# Release Notes

Kaizen Dynamic		Designer T Garvey	Sheet 3
Modification	2016/12/06	19:10	Title Mozilla Air Quality Monitor v1.3	
Edition	2016/12/06	19:16		
Sheet 3 PM2.5, temp/RH sensors & RGB LEDs			Project	SensorWeb

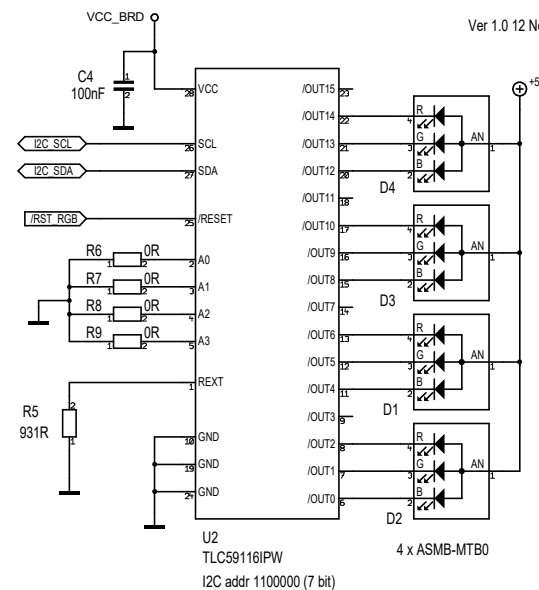
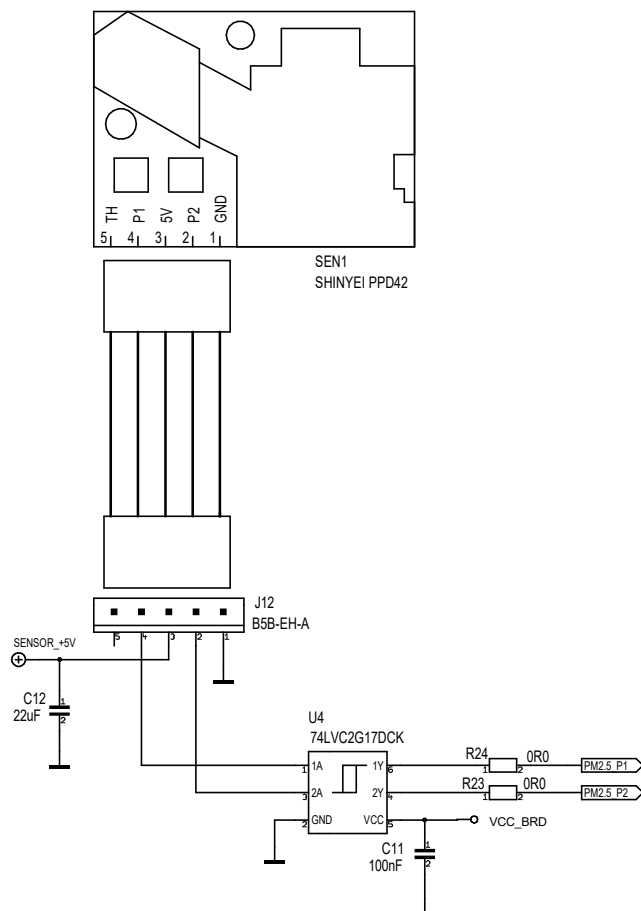
Ver 1.3 6 Dec 2016 Added C19 to sensor power supply LDO output.  
TPS61086 boost regulator circuit component changes.  
Removed J-Link programming header from Bluetooth circuit.  
Reassigned UART pins on Bluetooth module to aid PCB track routing.  
Reduced GPIO expansion connector to 2 pins.  
Component changes to fan drive circuit.  
Added Schmitt trigger circuit to PPD42 sensor signals.  
PPD42 P1 signal now connected to GT\_CCP04  
PPD42 P2 signal now connected to GT\_CCP03  
Component reference designator reorganisation.

Ver 1.2 21 Nov 2016 Added fan controller circuit.  
Component reference designator reorganisation.

Ver 1.1 15 Nov 2016 Changes to CC3200MOD pin mappings.  
Addition of switch to CC3200MOD GPIO22.  
Connection of CC3200MOD SOP2 and SRST to FT2232D pins.
